## Proposed Car Park at The Rock of Dunamase, Portlaoise

### ROAD SAFETY AUDIT STAGE 1 / 2

January 2023

### 2.2 Problem: Obstructed stopping sight distance

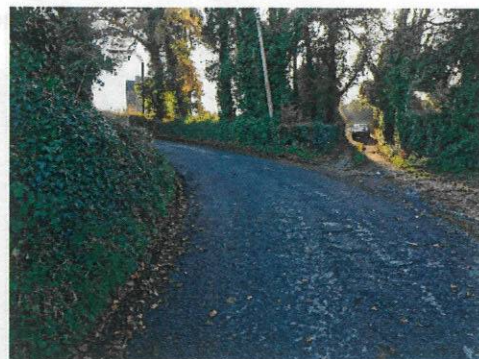
The length of stopping sight distance available around the bend on the mainline is deficient. A consequence is that intervisibility distance between a driver turning right into the car park access and an opposing northbound driver on the mainline may be insufficient. Downhill speeds of northbound traffic may be relatively high. These factors may increase the risk of turning collisions between vehicles at the access to the car park.

Remove or set-back the boundary on the east side of the road to ensure that adequate stopping sight distance is available.

### 2.3 Problem: Inconspicuous adjacent junction

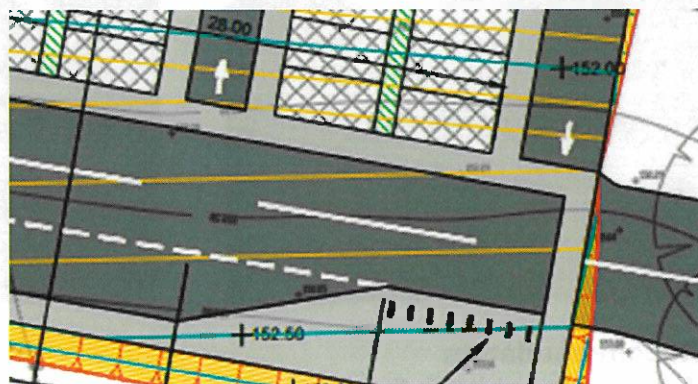
The adjacent public road junction is inconspicuous; it is obscured by the roadside boundary. A driver exiting the car park and checking to the left may not see the junction and may be taken unawares by a vehicle emerge from it. There is no junction warning sign on the northbound approach that, if present, would highlight the existence of the junction. Another issue relating to road safety is that the sightlines at the existing public road junction are very constrained (although that is a pre-existing issue not related to the scheme).

Remove or set-back the boundary sufficiently so that a driver exiting the car park has visibility of the adjacent public road junction. This would provide the additional benefit of improving the sightline to the right from the adjacent public road junction. Also, provide a junction warning sign on the northbound approach to the public road junction.

**Observations****2.6 Observation: No turning radii**

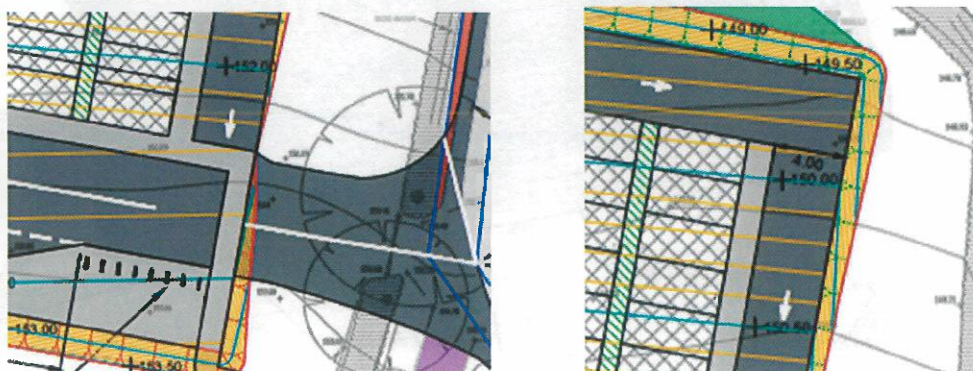
The insides of turns at junctions within the carpark have not been rounded. Drivers may find it difficult to turn with ease. Provide rounding on the insides of bends where traffic turns so that the paved surface provided is adequate to accommodate the swept paths of the turning vehicles.
